ARCHITECT'S SUPPLEMENTAL INSTRUCTIONS

PROJECT: Residence at Heritage West

Andover, KS

One (1)

C4.01

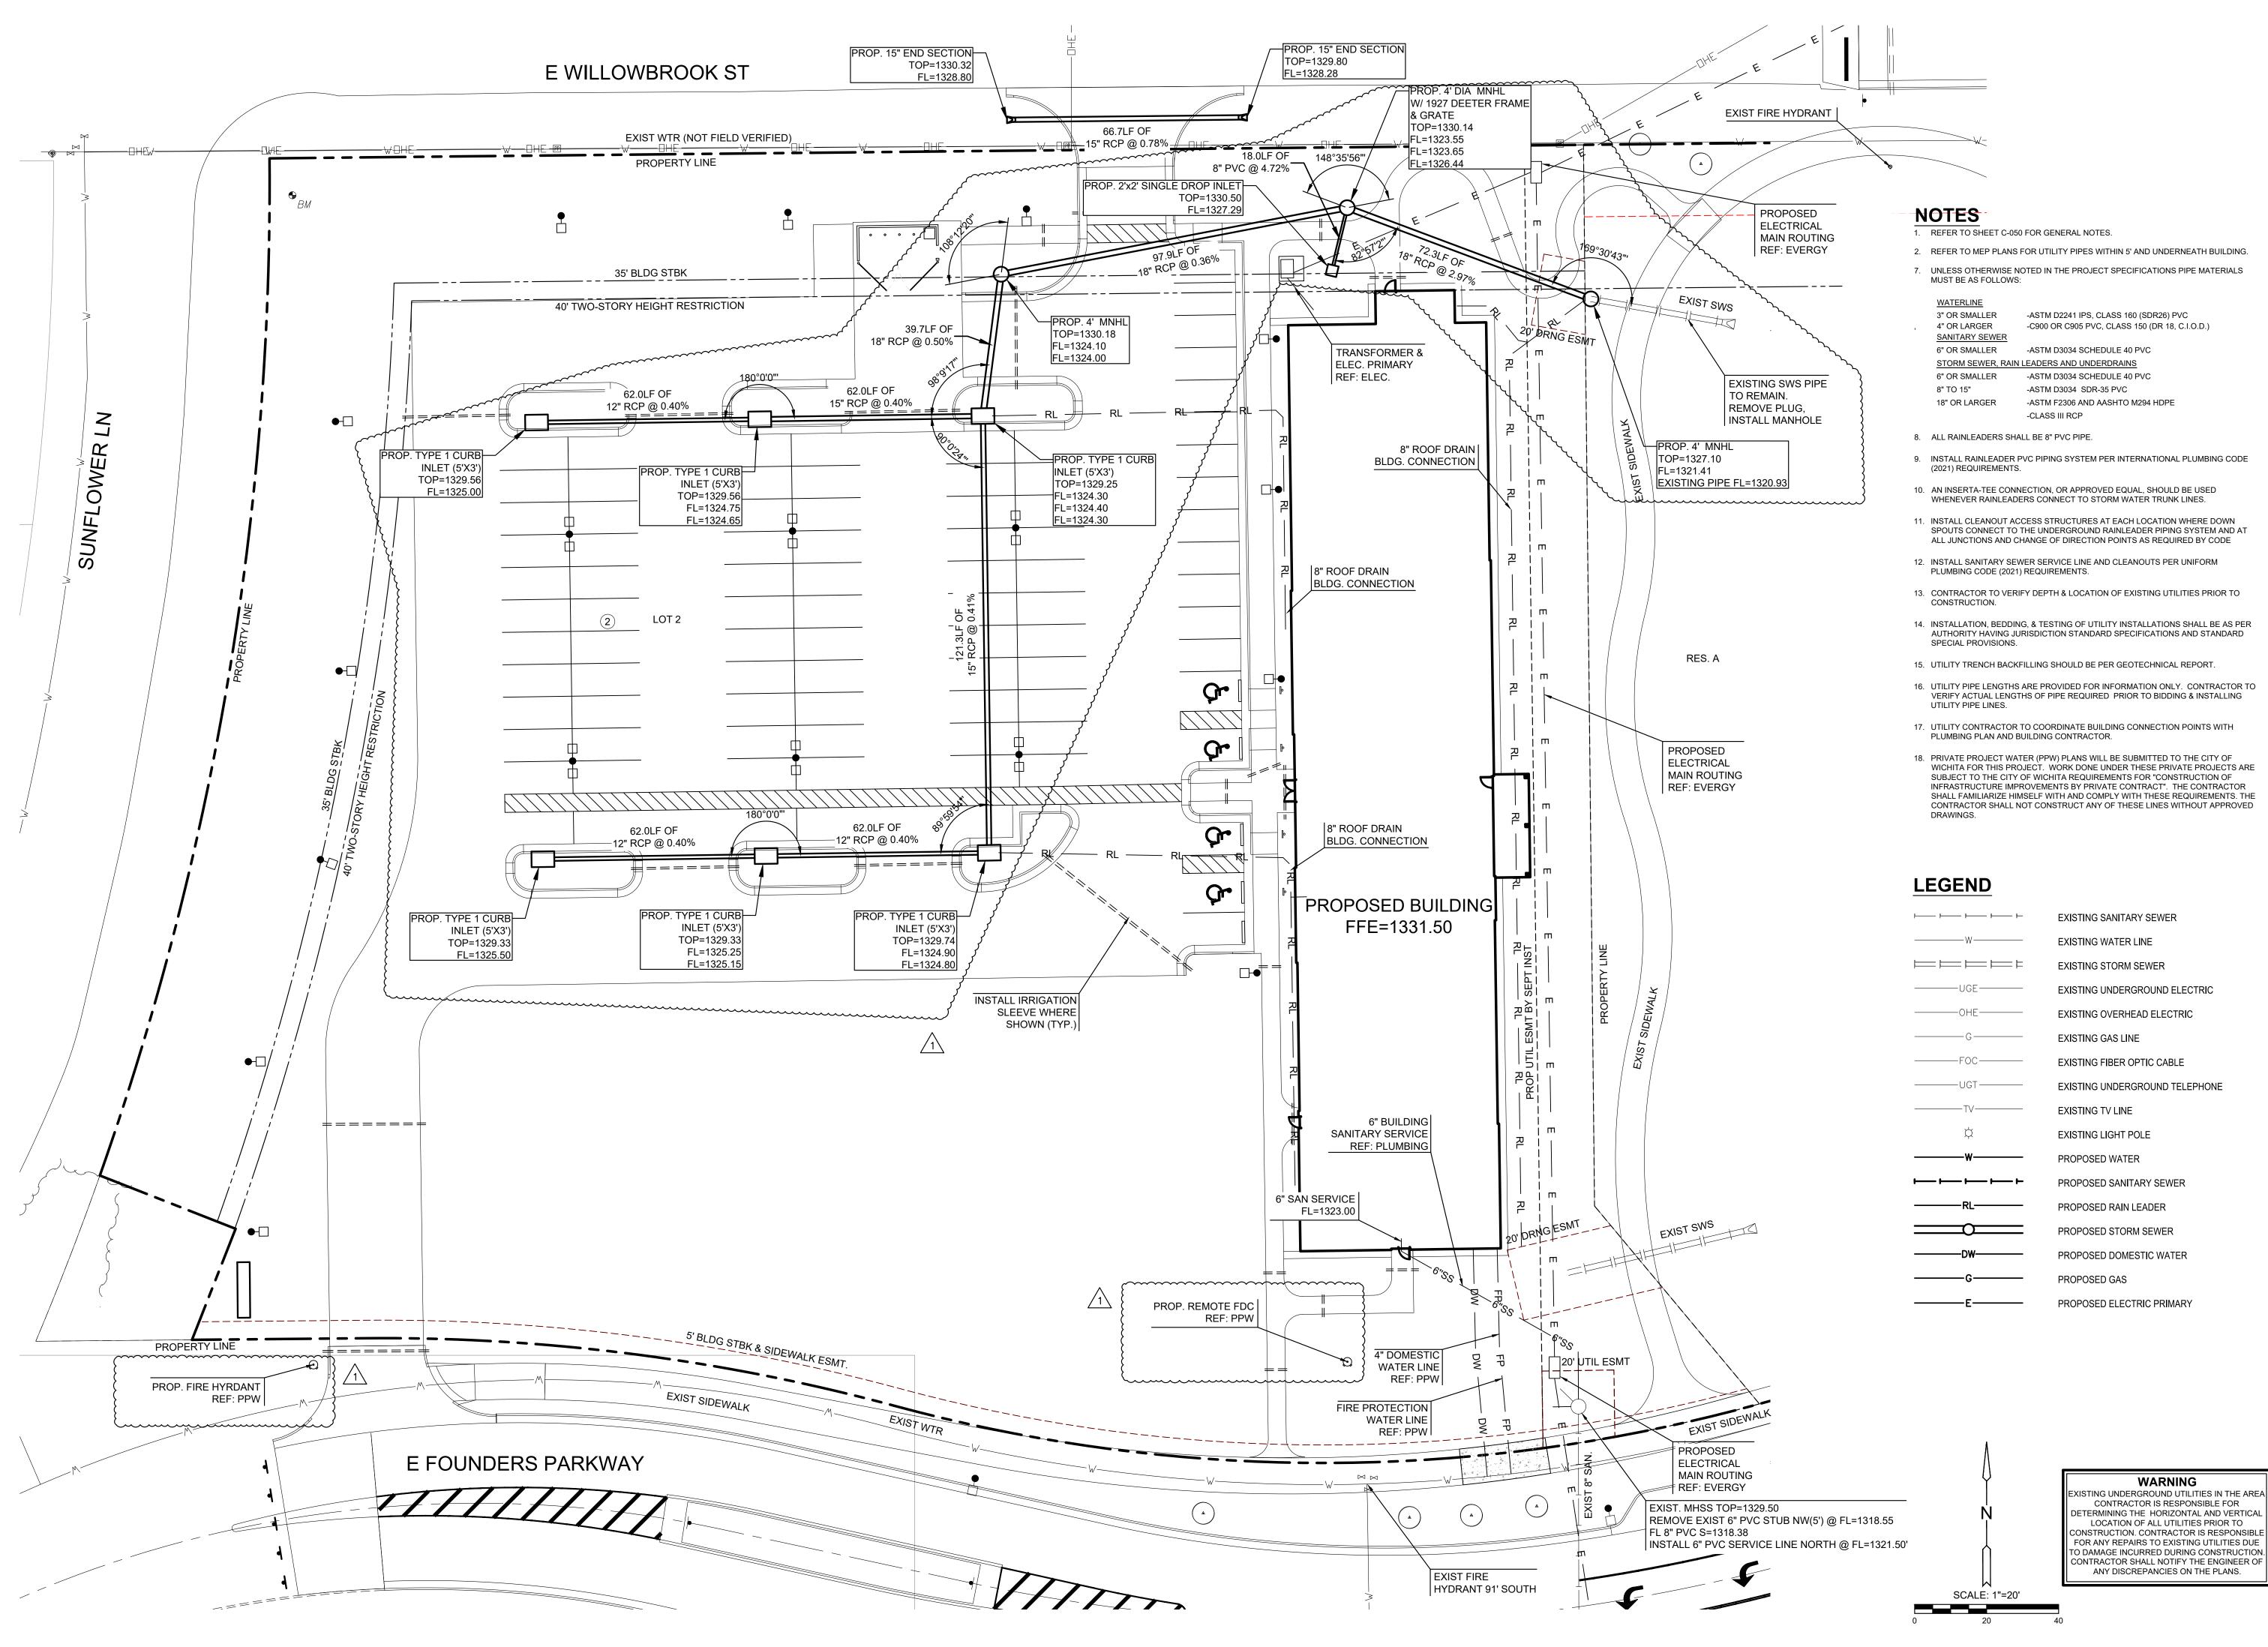
C4.01 Utility Plan – Modified storm sewer design to account for modified site layout.

C5.01

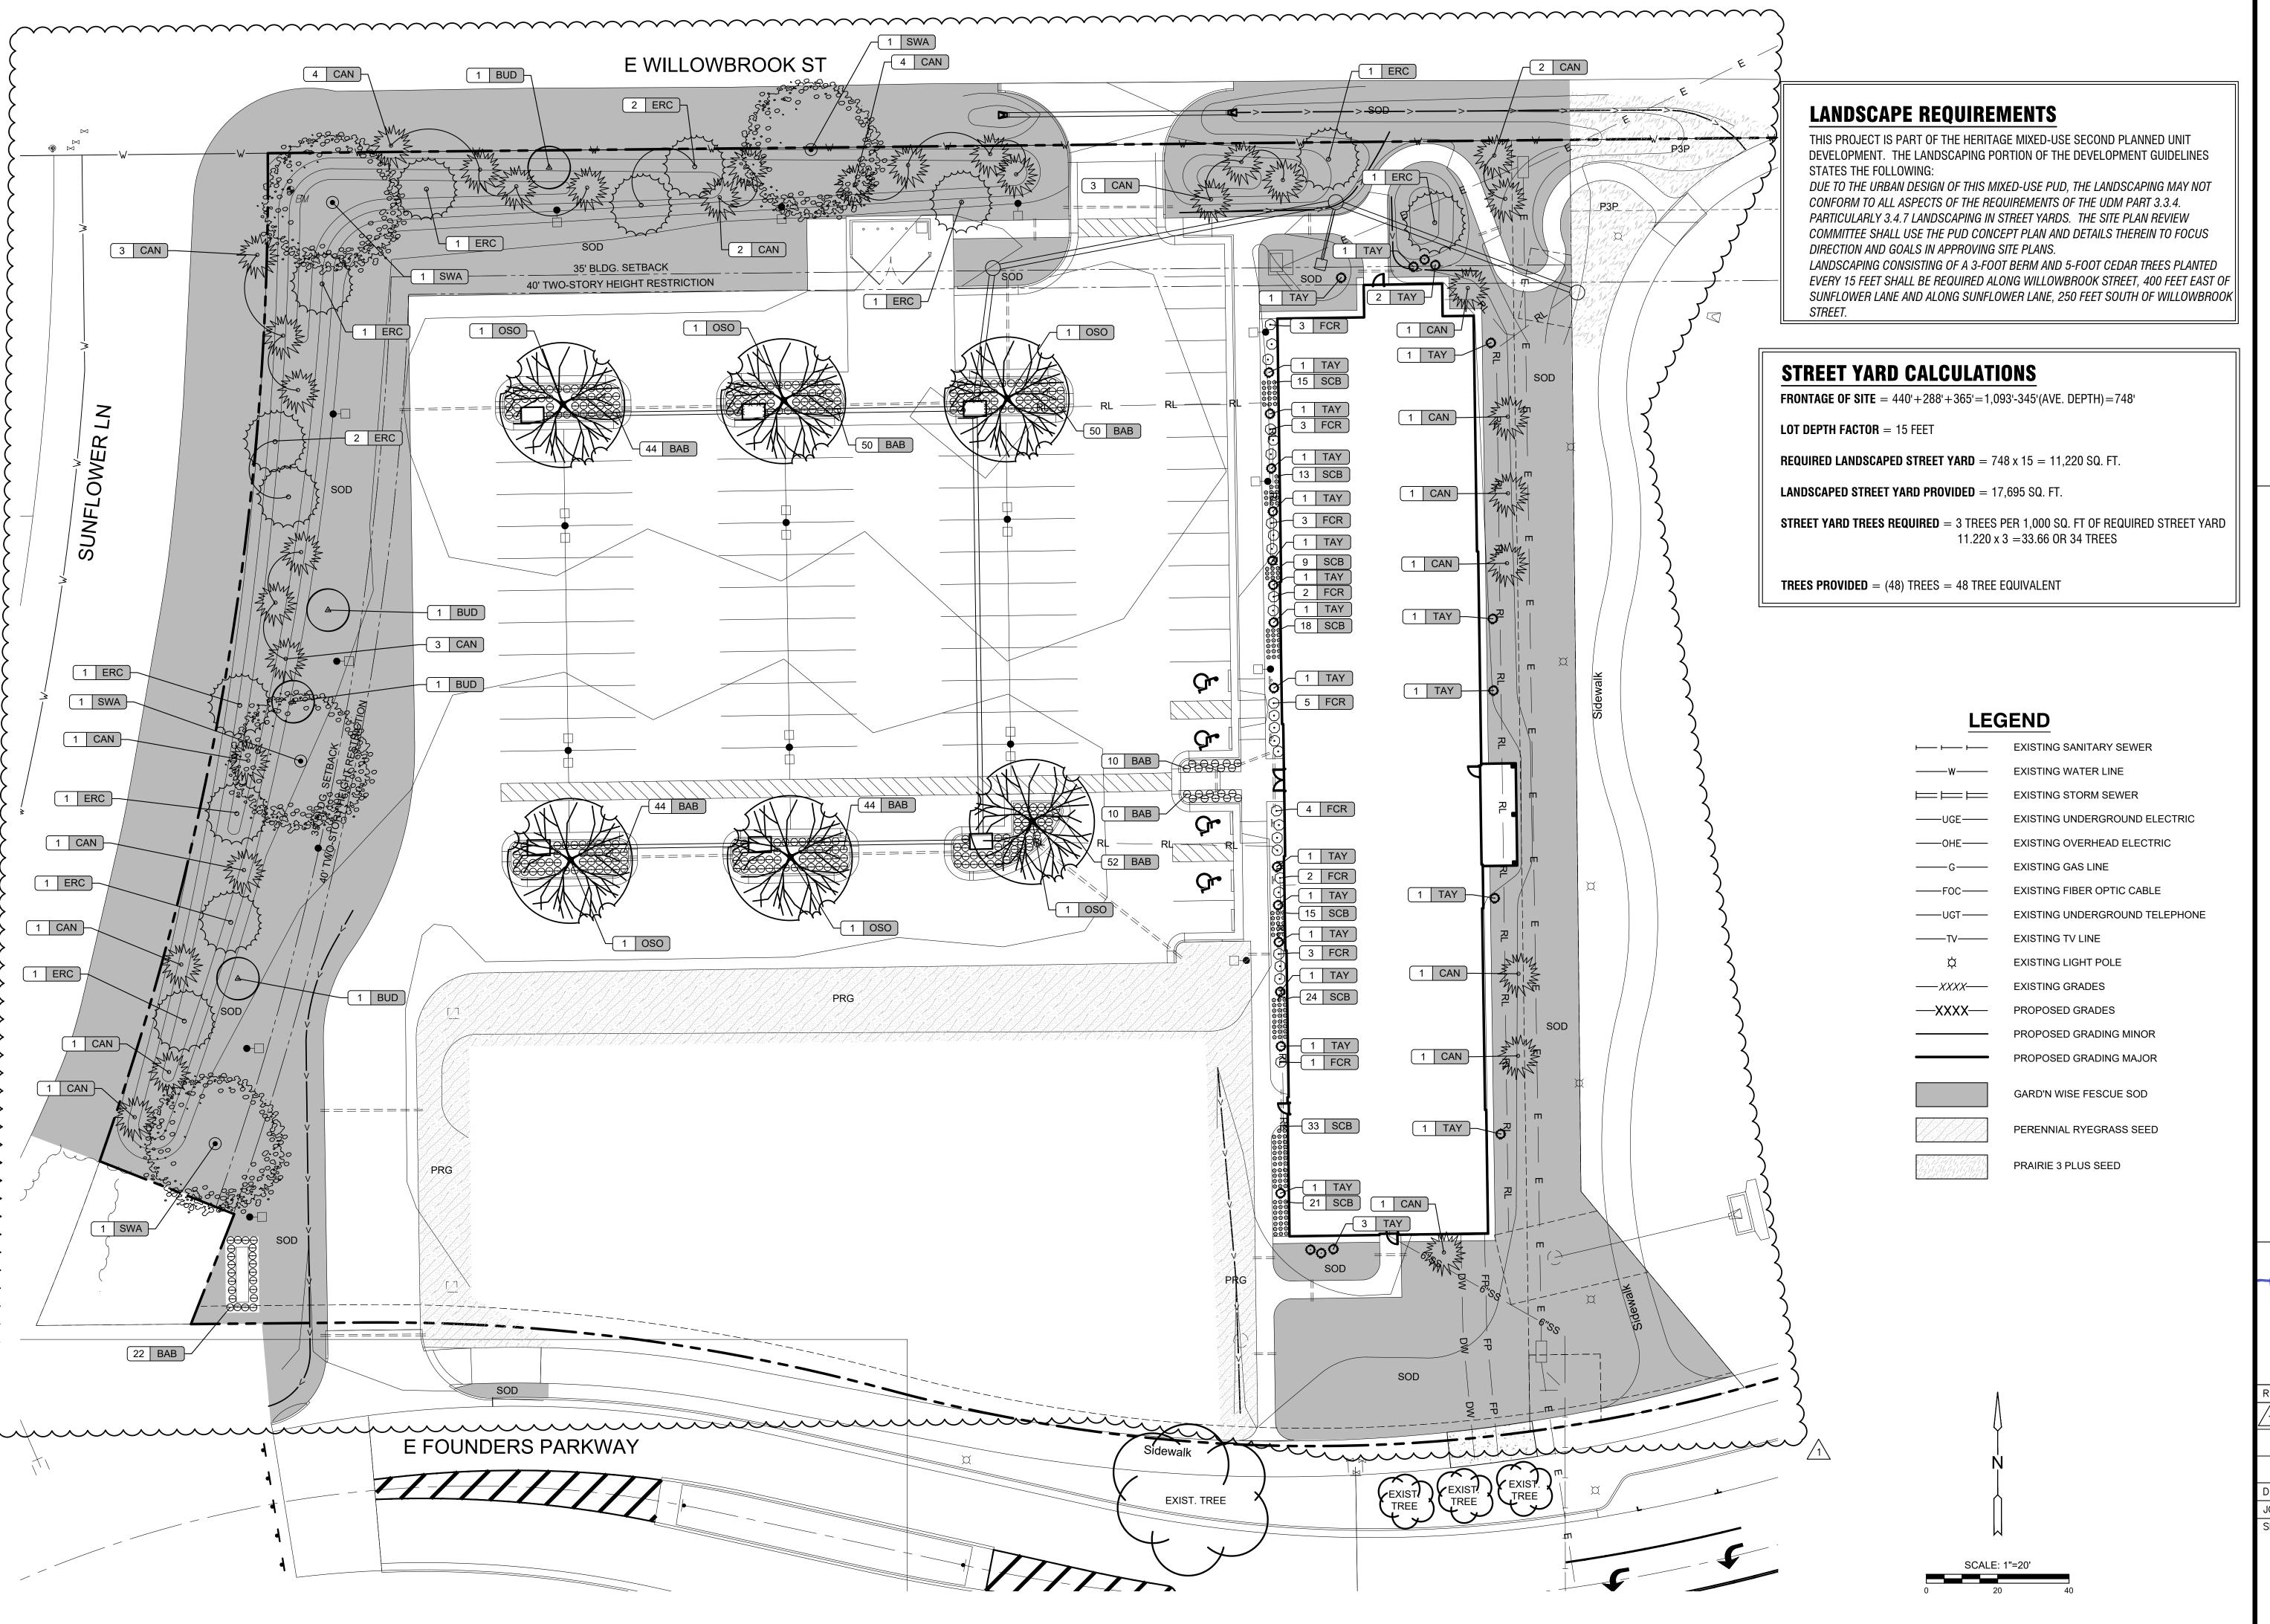
C5.01 Erosion Control Plan - Modified erosion control features to account for modified site layout and storm sewer changes.

L1.00

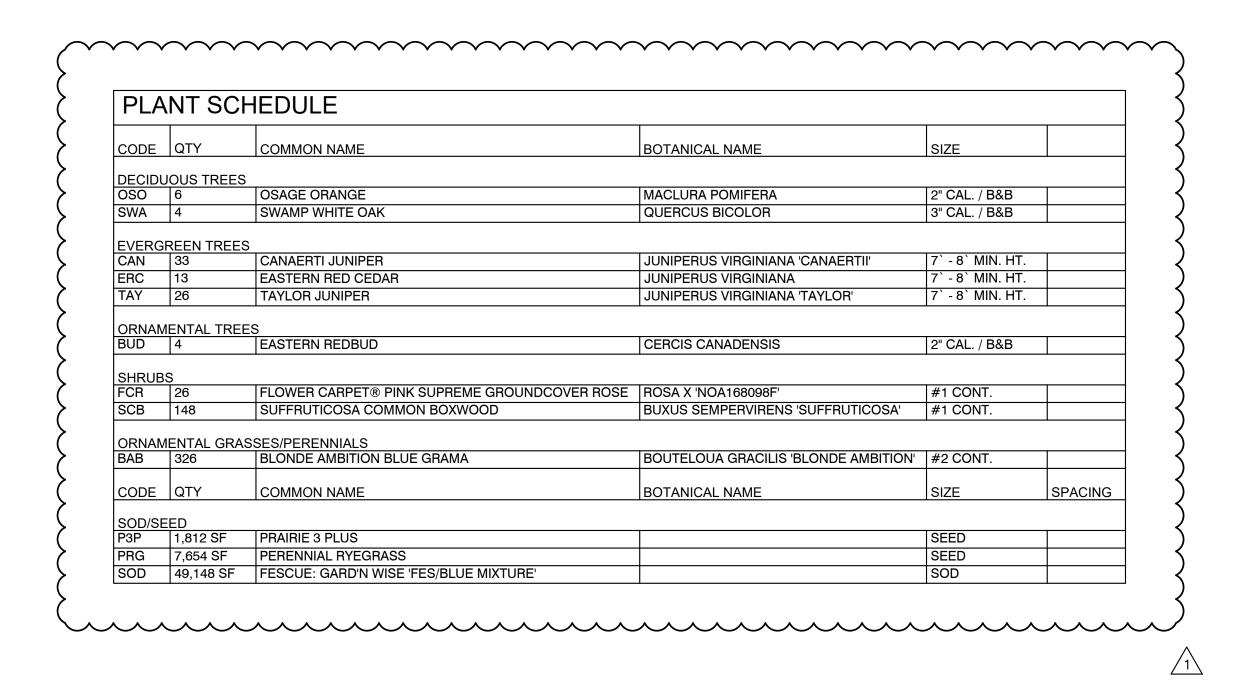
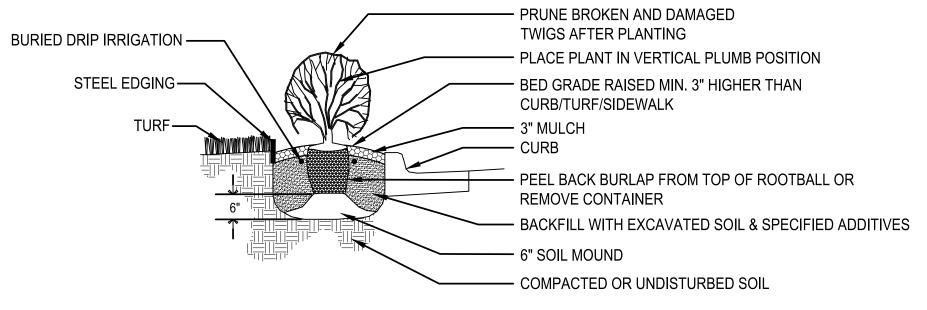
L1.00 Landscape Plan - Modified landscape design to account for modified site layout.

L1.01

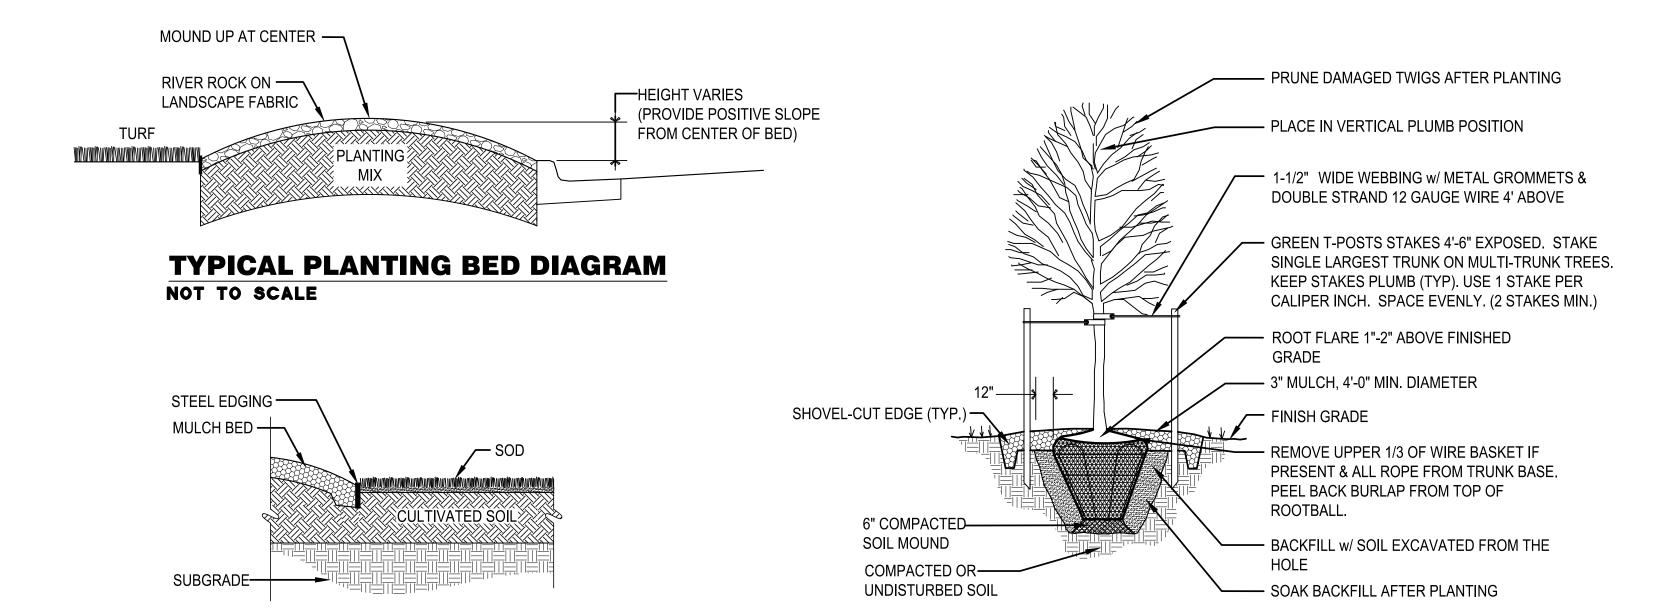
L1.01 Landscape Details - Updated plant schedule.
